**To:** Mr. James Smith, USNRC  
**From:** Stephen F Dwyer, PhD, PE, Dwyer Engineering, LLC  
**Date:** 7-31-20  
**Re:** UNC Response to USNRC's June 26, 2020 Clarification Request on the November 18, 2019 Supplemental Submittal to the Application for Amendment of USNRC Source Material License SUA-1475 for the United Nuclear Corporation Mill Site, McKinley County, New Mexico.

## **1. Clarification on Consolidation Modeling**

Figure 1. MCC for Alluvium at Base of Profile B8

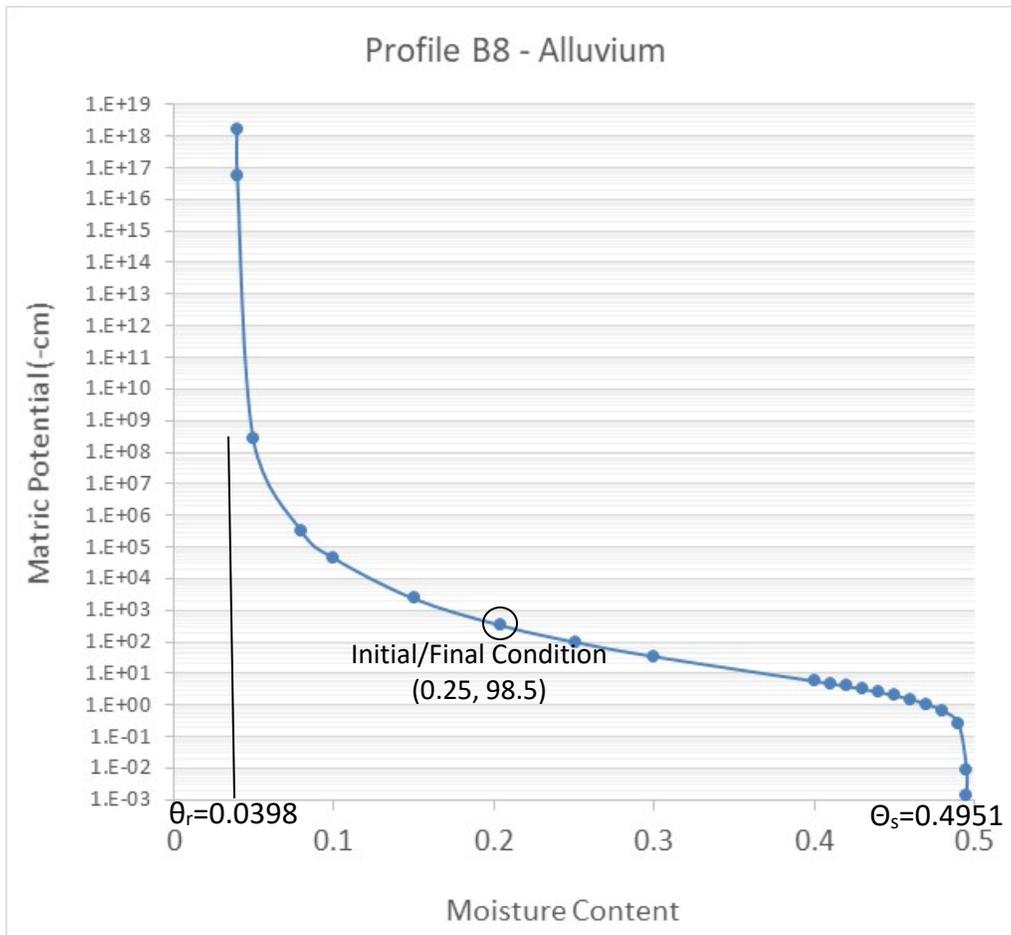
1. Clarification on the consolidation modeling scenarios evaluated for Appendix Y and how the scenarios would be impacted by effects of using the soil excavated from the jetty as borrow material for the Repository cover system and increasing the ET Cover thickness from 4 to 4.5-ft.
2. Characteristics of the alluvium underlying the tailings impoundment.
3. Clarification of the revised cover design based on use of Jetty material.

The following information related to the alluvium soil included in the simulations is included below at the request of the USNRC. The moisture characteristic curve data used for the alluvium soil for Profile B8 was derived from soil sample B1-13A. The respective curve is shown in Figure 1. The initial soil conditions for the alluvium in the profile B8 simulations was set at a matric potential of -98.5 cm.
